UNITED STATES
NUCLEAR REGULATORY COMMISSION
WASHINGTON, D. C. 20555

RHODE ISLAND ATOMIC ENERGY COMMISSION

AMENDMENT TO FACILITY OPERATING LICENSE

Amendment No. 15
License No. R-95

FIGURE A.1 PORTION OF NARRAGANSETT BAY CAMPUS OF URI SHOWING LOCATION OF REACTOR BUILDING

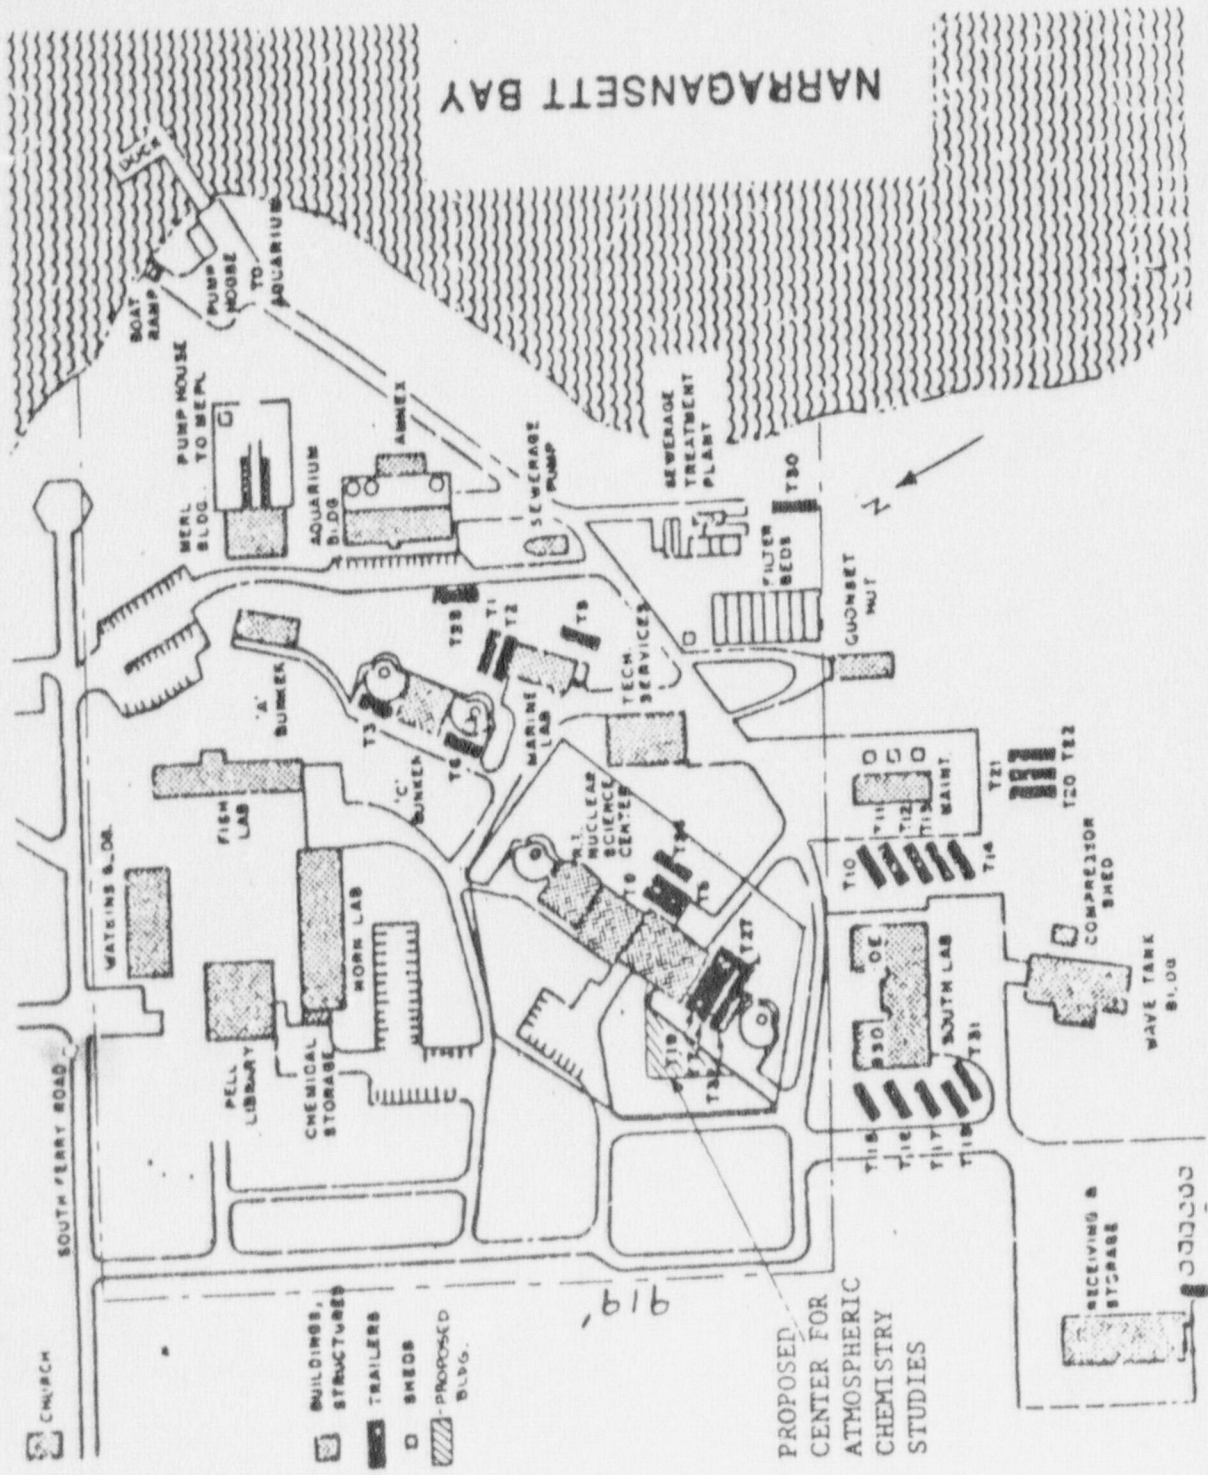
Figure A.1 is a drawing of the Narragansett Bay Campus showing the three acre Nuclear Science Center site. The boundary of this area shall be posted with conspicuous signs to delineate the area. This three acre area shall be the exclusion area as defined in 10 CFR 100.

Figure A.1 also shows the location of the reactor building on the three acre area. The reactor building and attached office laboratory wing shall be considered the restricted area as defined in 10 CFR 20.

The principal activities carried on within the restricted and exclusion area shall be those associated with operation and utilization of the reactor. It shall be permissible to locate additional Nuclear Science Center or University of Rhode Island buildings within the exclusion area provided that these additional buildings are capable of timely evacuation and do not interfere with the operation of the reactor.
